# CITY OF ALBUQUERQUE

**Re: Touro College of Dental/ Tenant Improvements**  
**2425 Ridgecrest Dr. SE**  
**Traffic Circulation Layout**  
Architect's Stamp 05-17-24 (M18-D006)

The TCL submittal received 05-10-2024 is approved for Building Permit by Transportation. A copy of the stamped and signed plan will be needed for each of the building permit plans. Please keep the original to be used for certification of the site for final C.O. for Transportation.

## A1 TRAFFIC CIRCULATION LAYOUT: ON-SITE

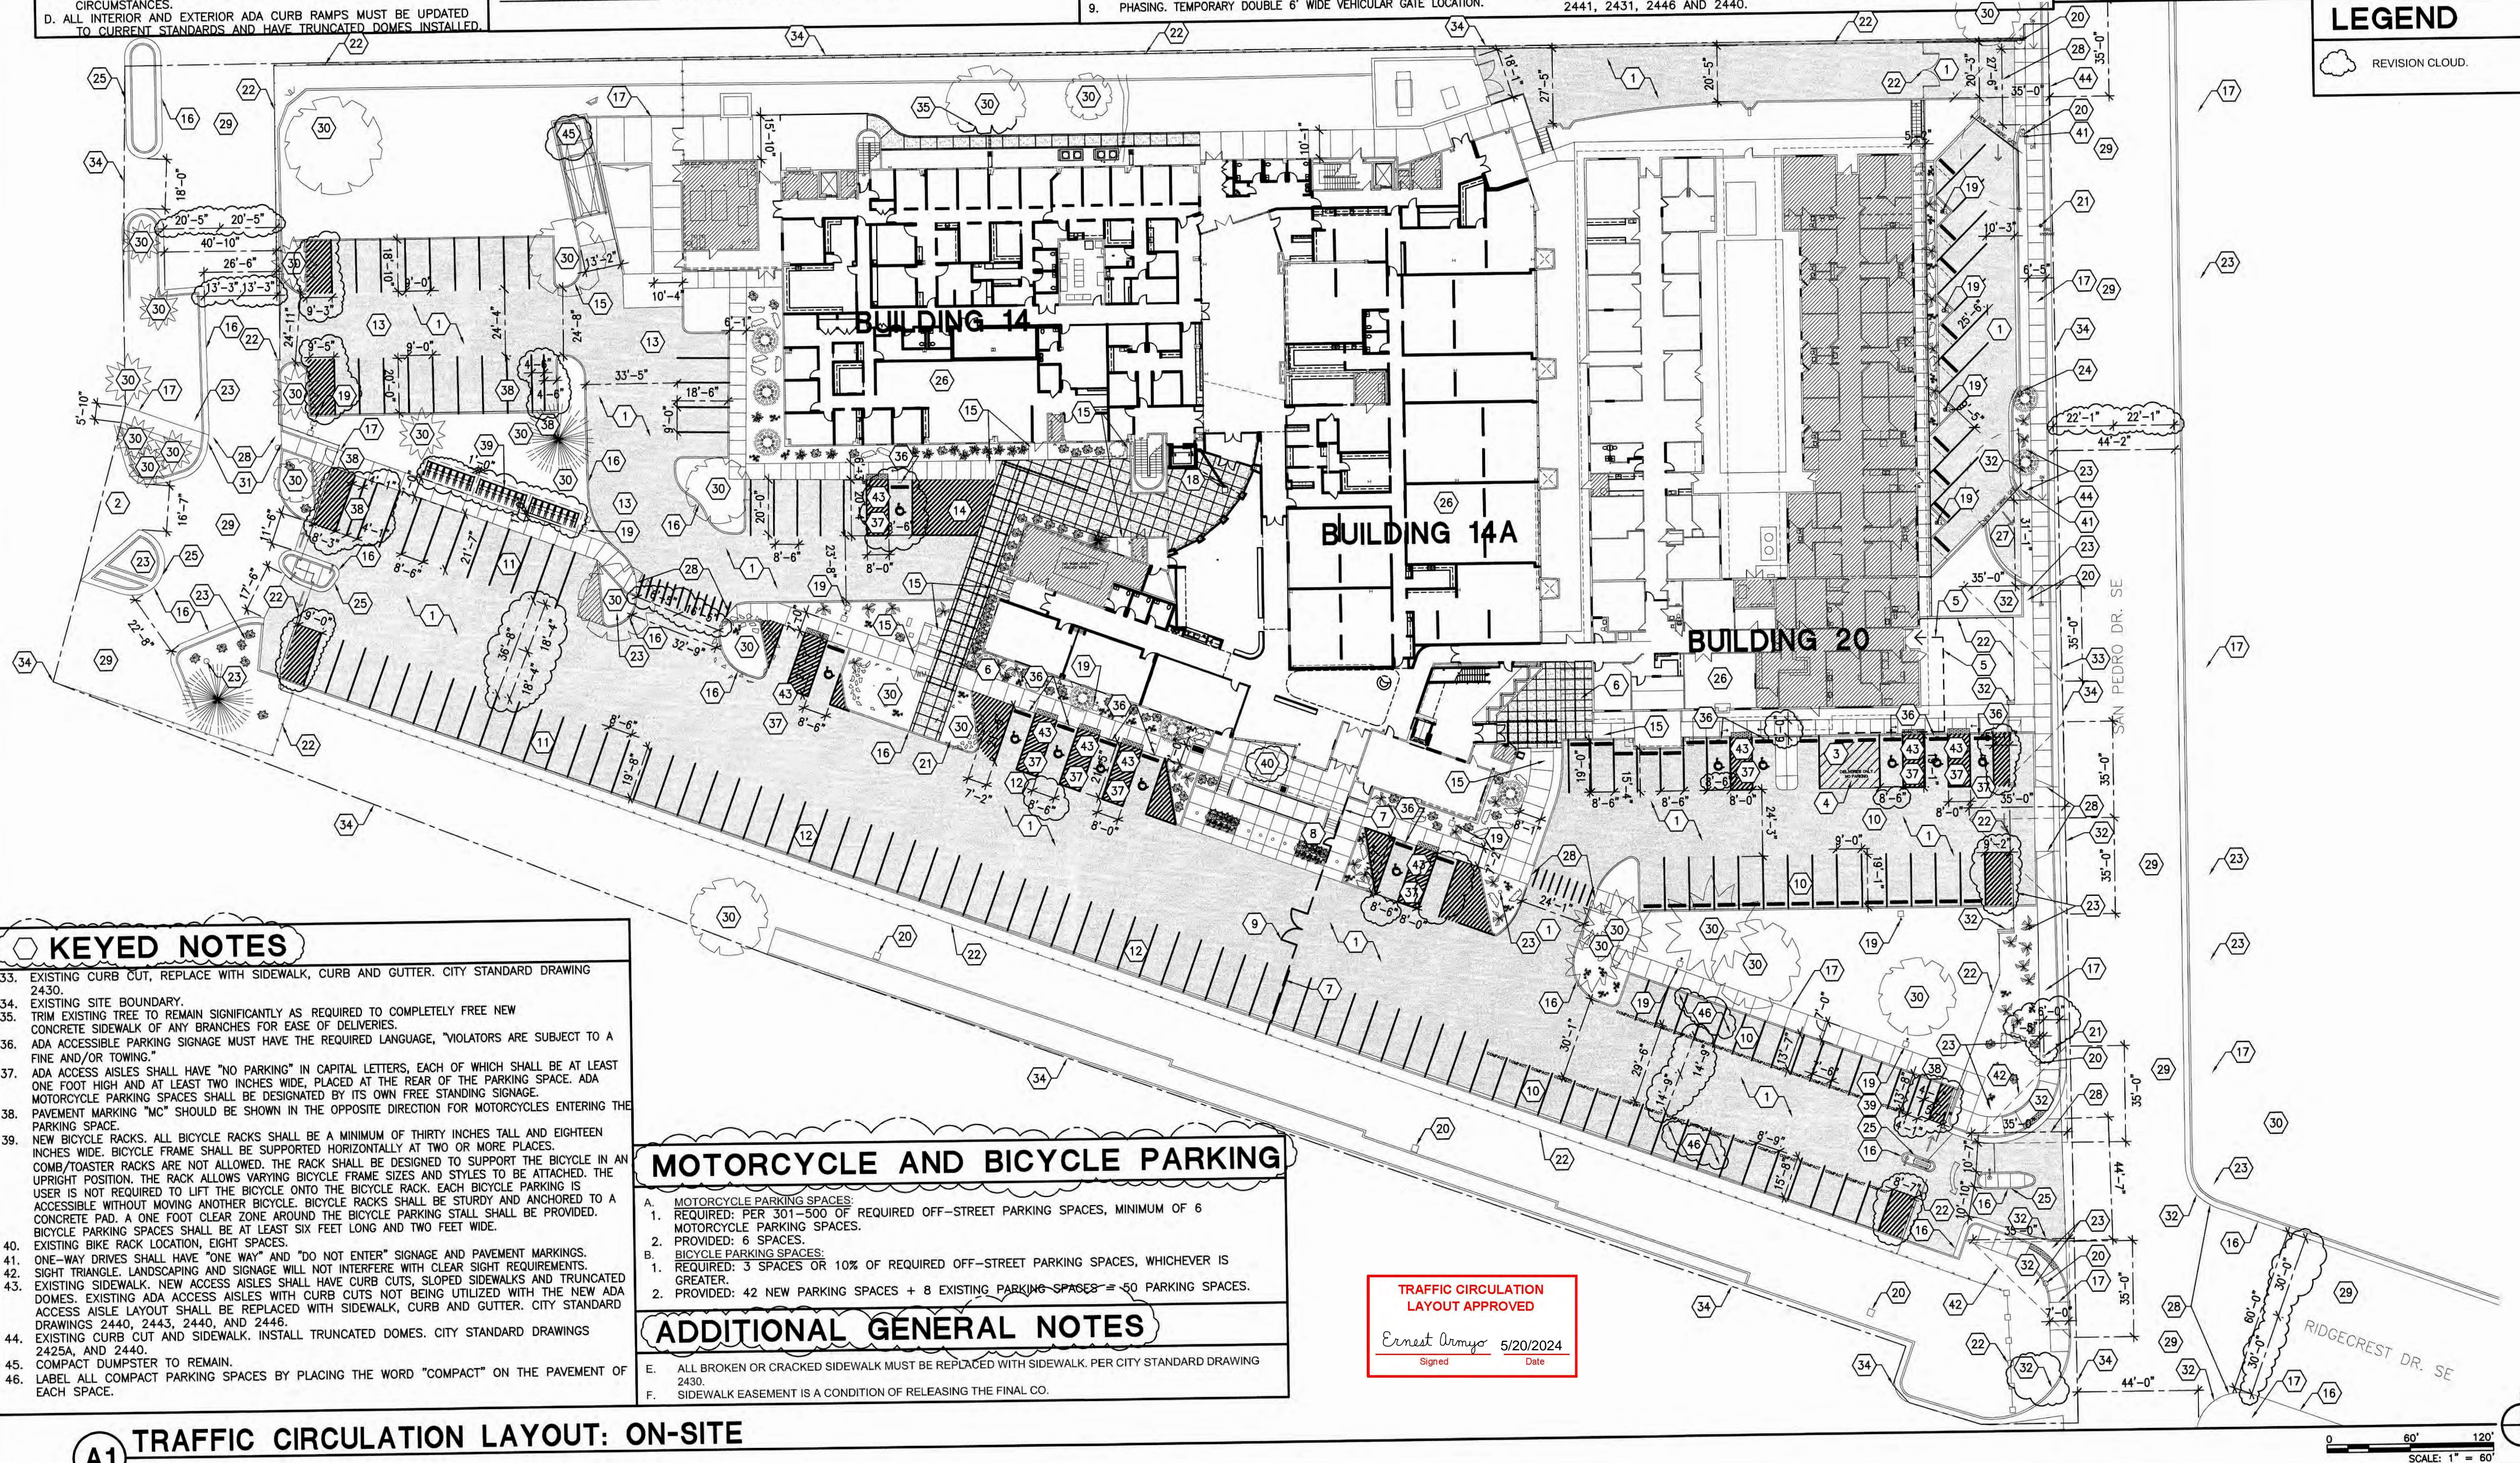
When the site construction is completed and an inspection for Certificate of Occupancy (C.O.) is requested, use the original City stamped approved TCL for certification. Redline any minor changes and adjustments that were made in the field. A NM registered architect or engineer must stamp, sign, and date the certification TCL along with indicating that the development was built in "substantial compliance" with the TCL. Submit this certification, the TCL, and a completed Drainage and Transportation Information Sheet to front counter personnel for log in and evaluation by Transportation. **CONDITIONS OF RELEASING THE FINAL CO:**

- 1. APPROVED SIDEWALK EASEMENT.**
- 2. PROVIDE A MINIMUM COMPACT PARKING LENGTH OF 15 FT.**
